ADDENDUM NO. 01 June 24, 2025

To Drawings and Specifications dated June 10, 2025.

PKG 3A – GPHS New Fieldhouse

Prepared by:	PBK
	11 Greenway Plaza, 22 nd Floor
	Houston, TX 77046-1104
	PBK Project No: 240539

Item No. 01 M-101 - 1ST FLOOR MECHANICAL PLAN

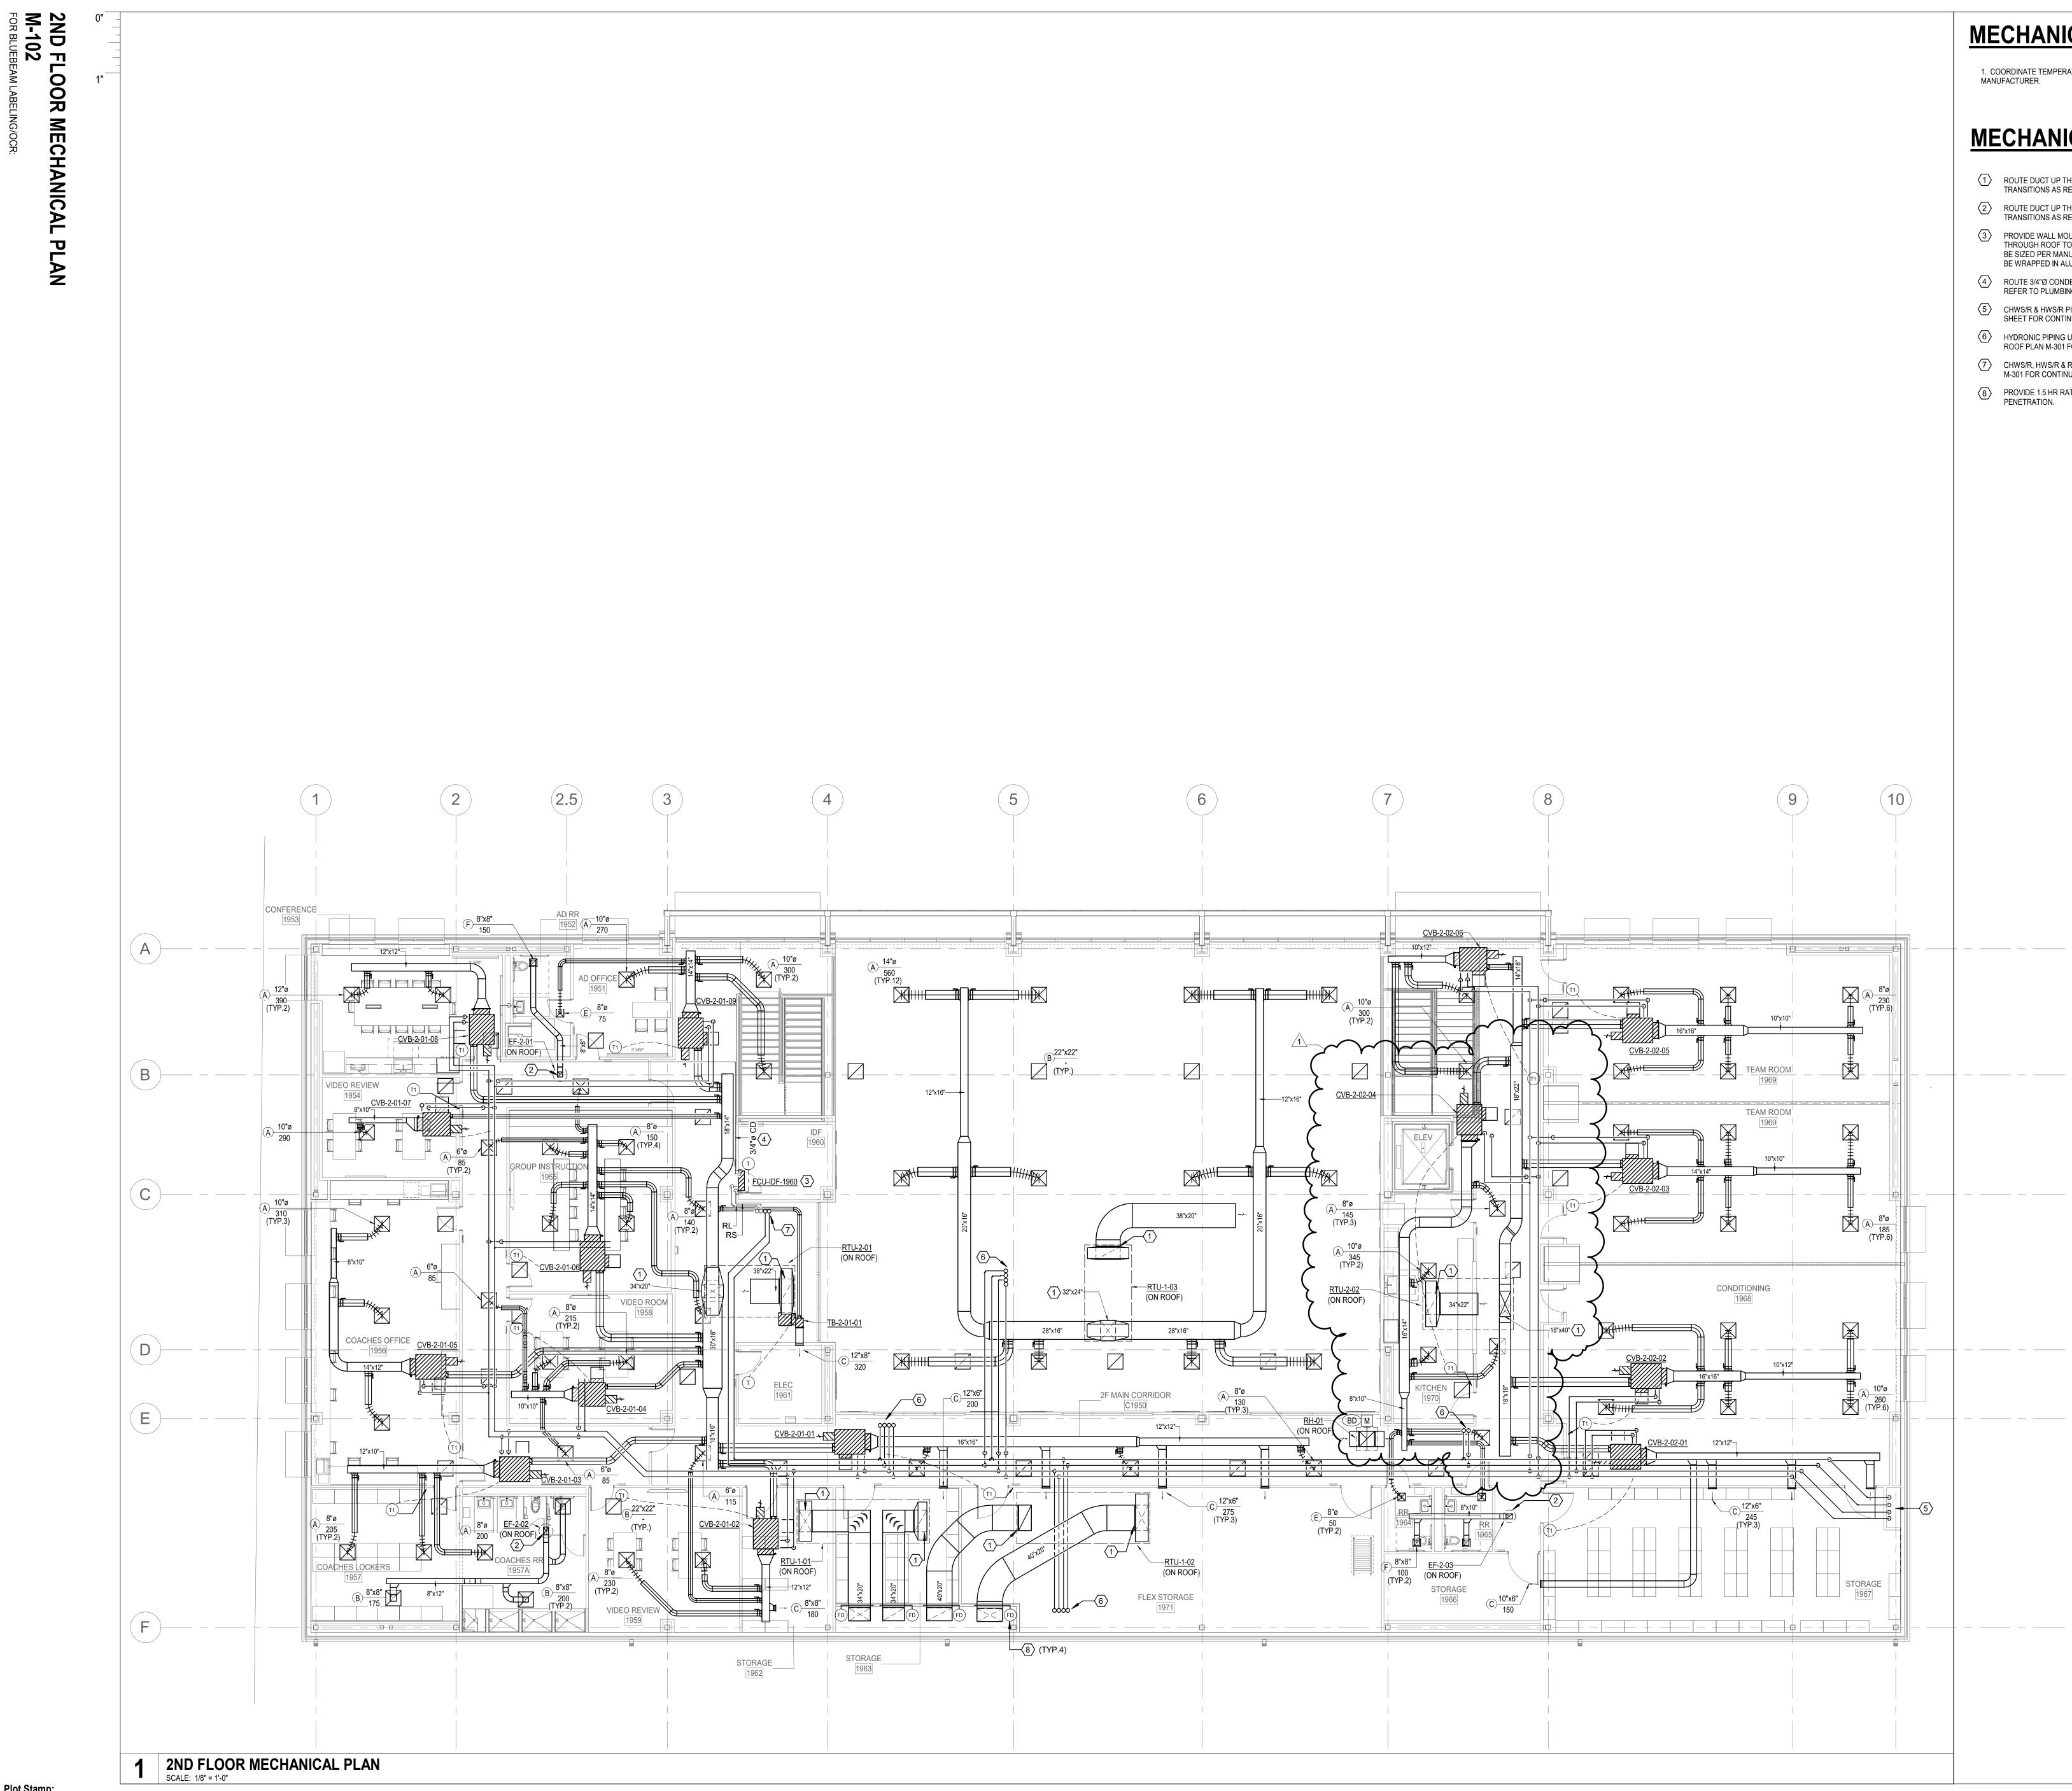
- A. Missing thermostat added for FCU in Riser Rm-1907.
- B. Added keynote 14 stating "ALL OUTDOOR REFRIGERANT PIPING SHALL BE WRAPPED WITH ALUMINUM JACKET. PROVIDE WALL SUPPORTS AT EVERY 3' INTERVALS" to refrigerant piping of ACCU-1907
- C. Now showing housekeeping pad for ACCU-RISER RM-1907. Also added the following to keynote 13: "GC TO COORDINATE PAD DIMENSIONS AND LOCATIONS"

Item No. 03 M-201 – MECHANICAL ENLARGED PLAN

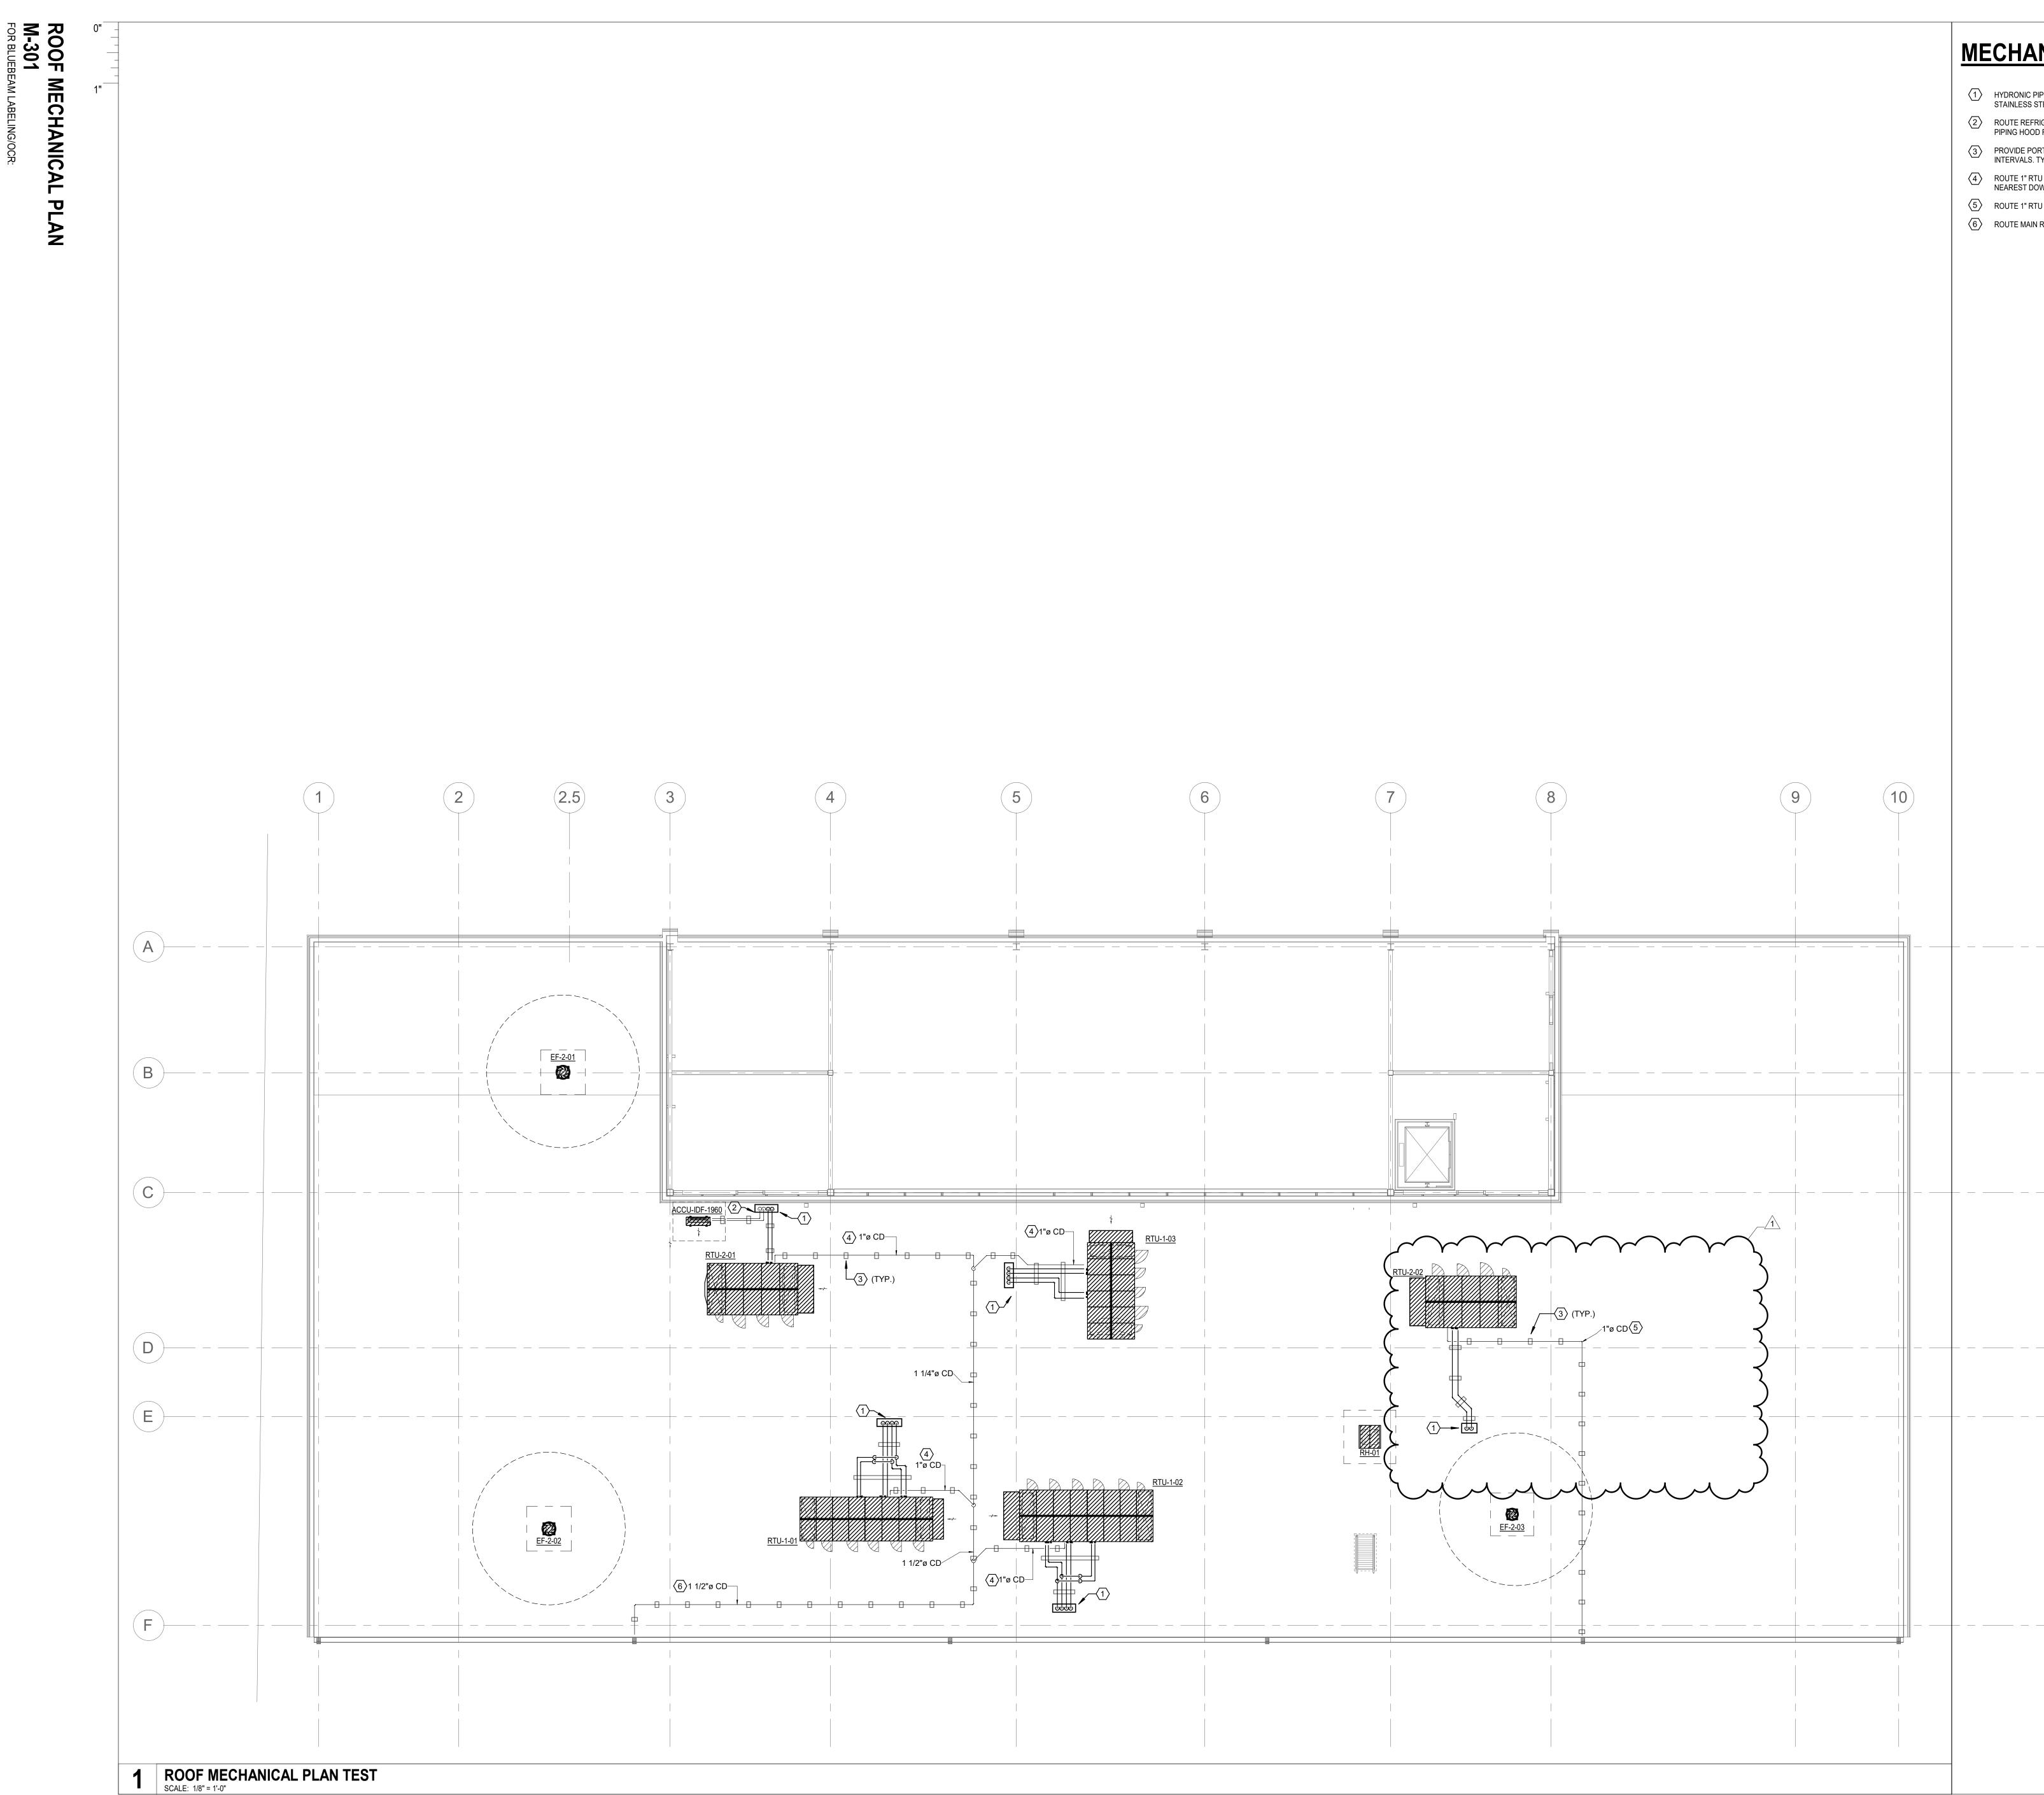
- A. Corrected B-01 dimensions on the enlarged plan.
- B. Added the following line to keynotes 3, 4, 7, 8, 9, and 11: "GC TO COORDINATE PAD DIMENSIONS AND LOCATIONS".
- C. Now showing housekeeping pads for B-01, ACCU-1913, and ACCU-01.

Plot Stamp: 6/24/2025 10:57:57 AM **1ST FLOOR PLUMBING PLAN** SCALE: 1/8" = 1'-0"

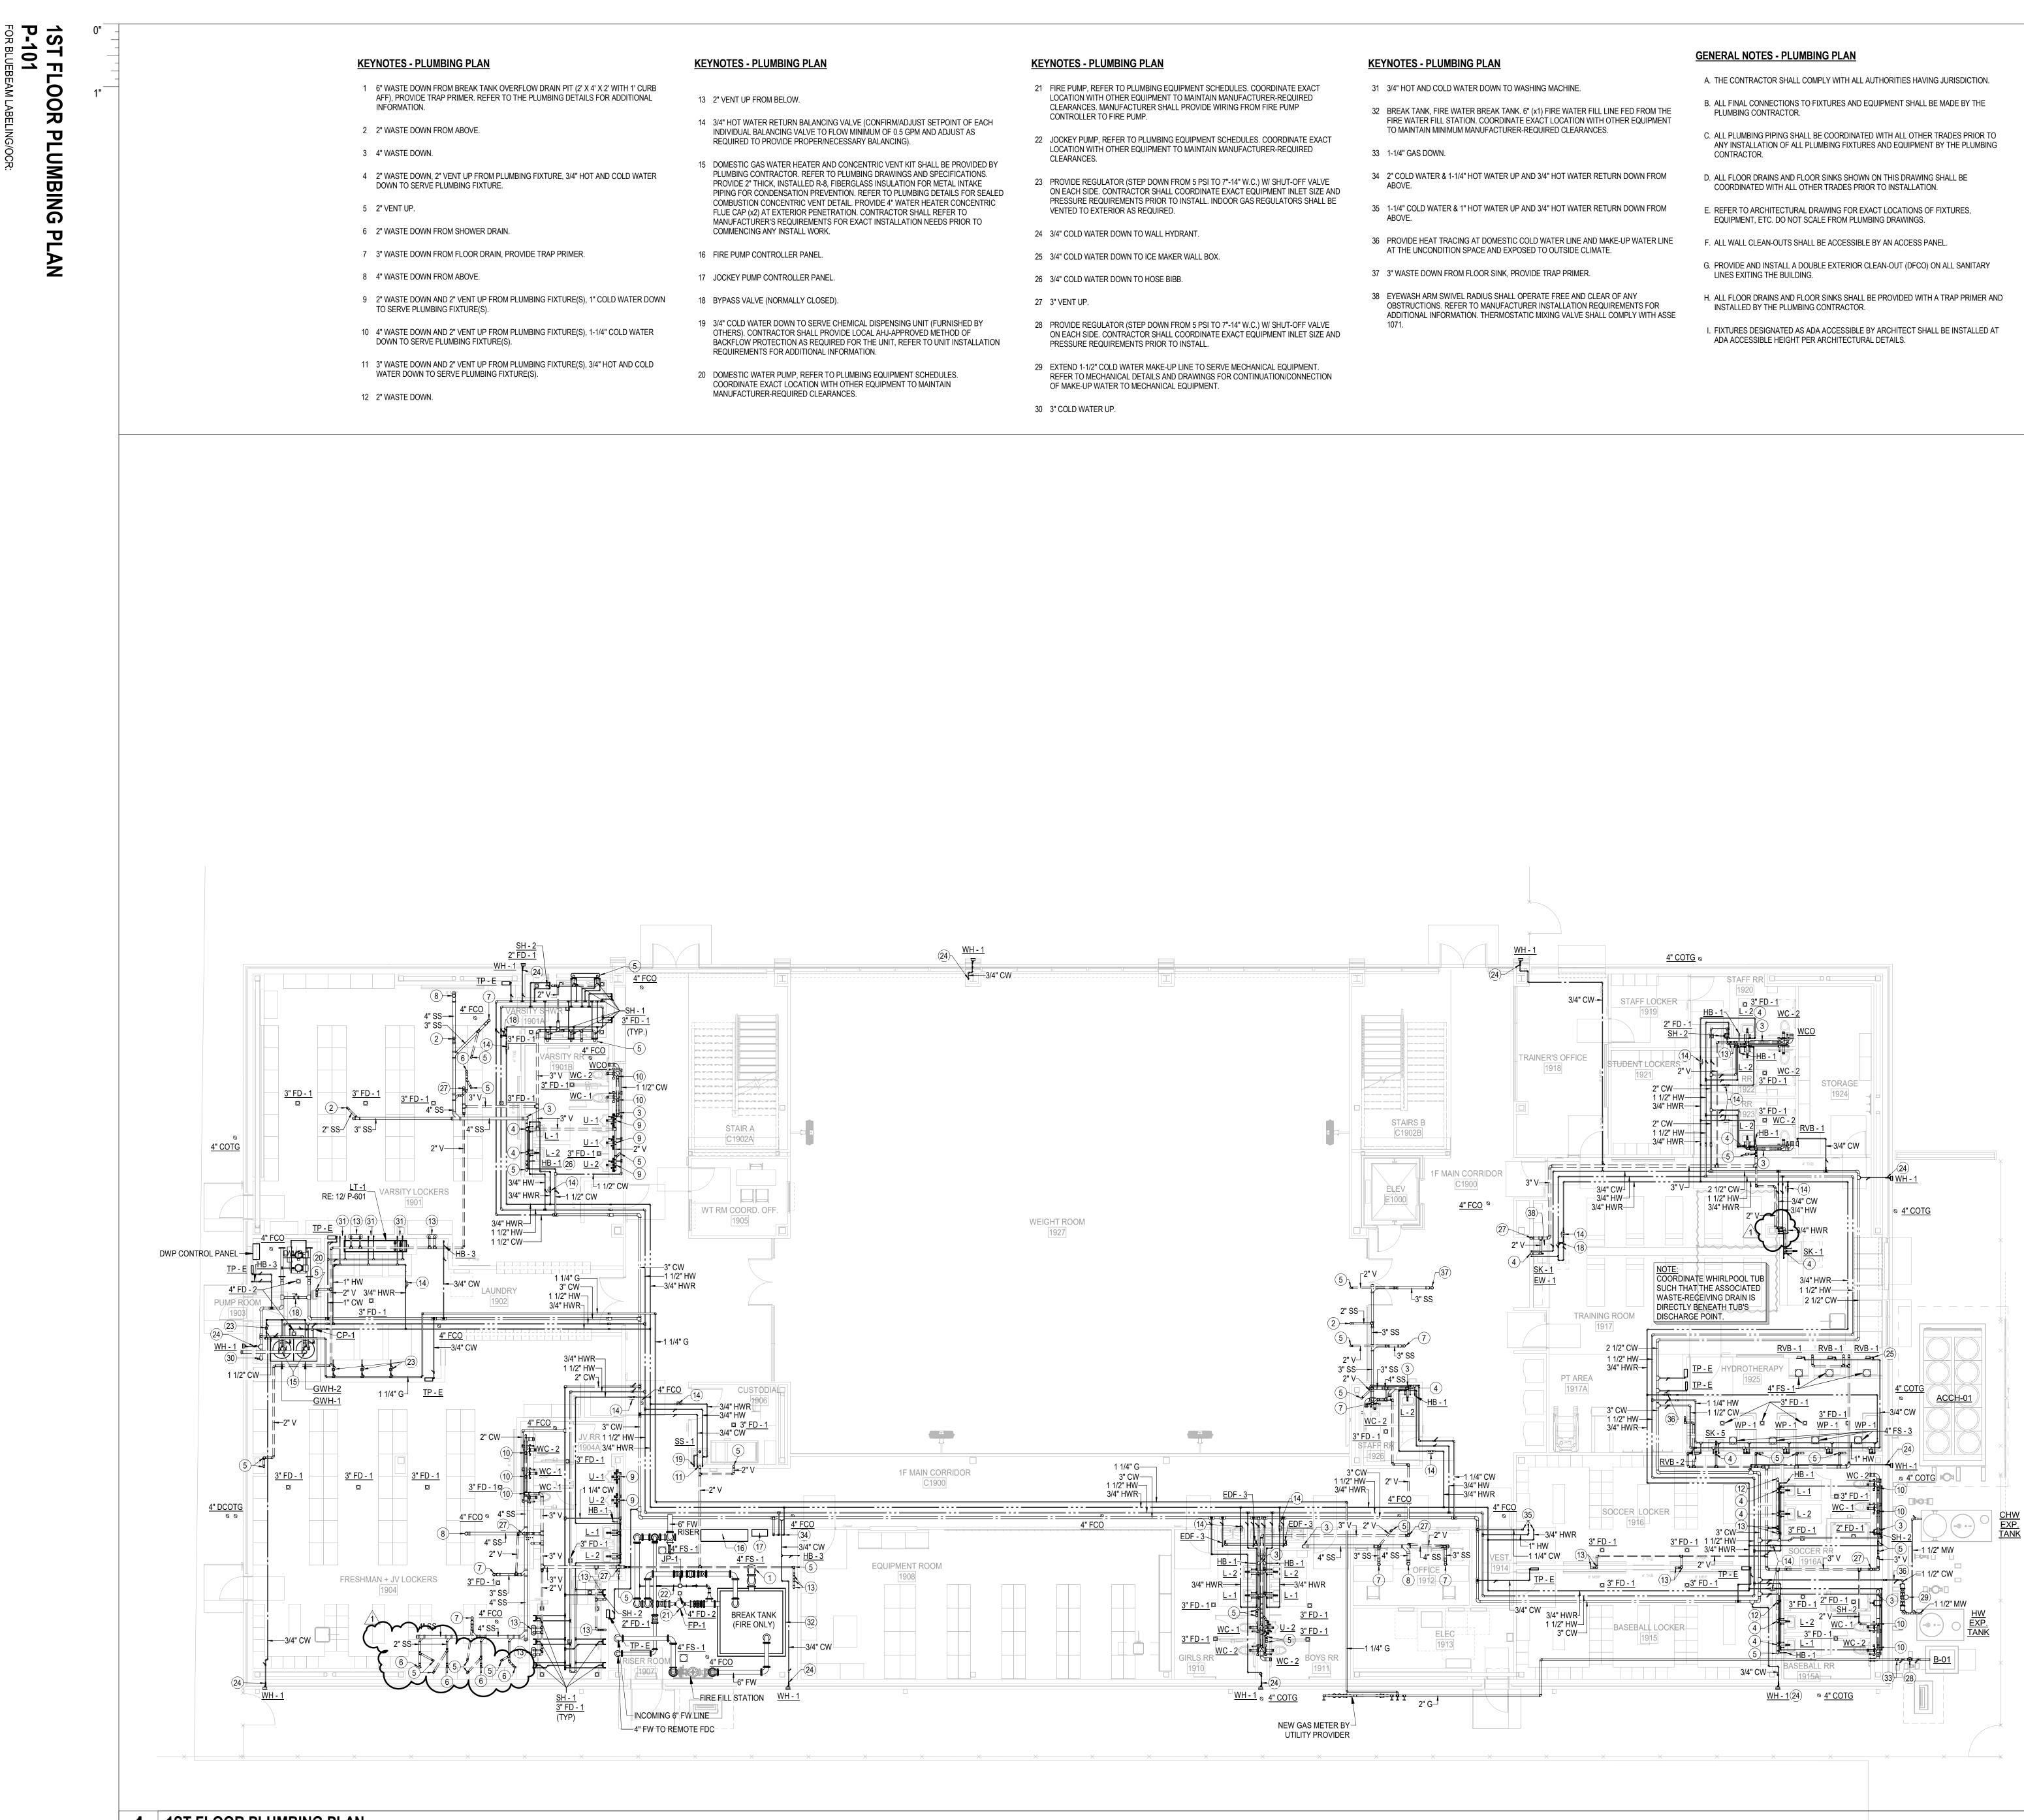
P101 – 1ST FLOOR PLUMBING PLAN
